**Proposal for a New Draft Regulation :**

**Uniform provision concerning the approval of wheels for passenger cars and their trailers**

Minutes of the GRRF Informal Group "passenger vehicles wheels" meeting held on Jan.18<sup>th</sup> 2002.

Revision 4

Figure 1 : wheel inner contour including examples of inside and outside situations.

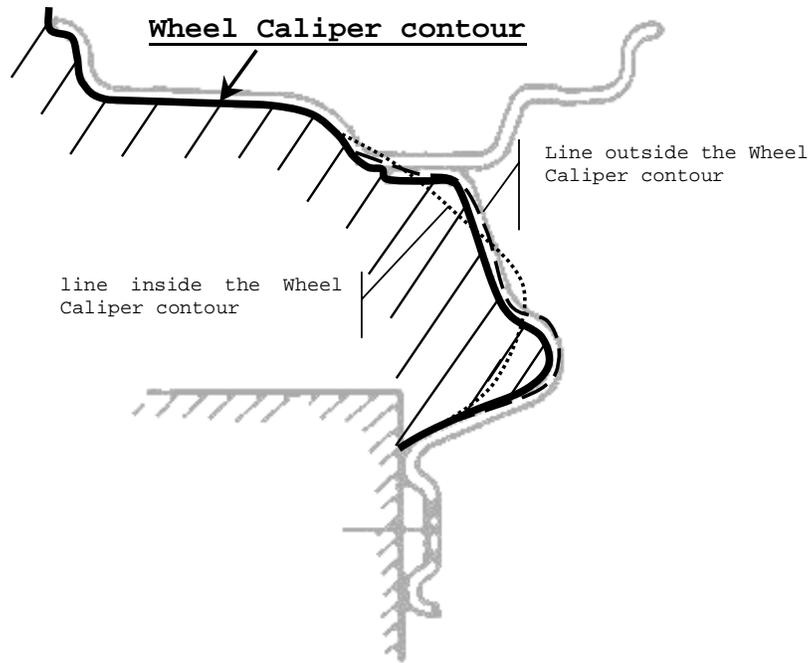
3.2. *Wheel caliper check*

The design of the inner contour of the wheel (see figure 1) must provide sufficient space for the brake, suspension and steering components.

*In the case where the wheel caliper is the same as outside the OE-wheel caliper, no verification is necessary.*

*In the case where the wheel caliper is inside the OE-wheel caliper, there shall be sufficient clearance in under all conditions of steering and suspension travel which occur in normal driving. For that reason, tests shall be carried out in order to ensure that the wheel assembly has sufficient space in the wheel housing and does not contact any vehicle part component.*

*As a rule, the following criteria have to be fulfilled:*

*minimum clearance for brake components (worst case, for example with new brake linings): 3 mm <sup>1/</sup>),*

*minimum clearance for suspension components (e. g. upper and lower suspension arms): 4 mm,*

*minimum clearance for steering components (e. g. track rod and steering joints ): 4 mm, and*

*minimum clearance between balance weights and vehicle components: 2 mm*

*The check shall be carried out statically. Alternative methods are acceptable if the test results are . If the various clearances on the CE equipment are less than those given above, then these can be accepted for the special wheel.*
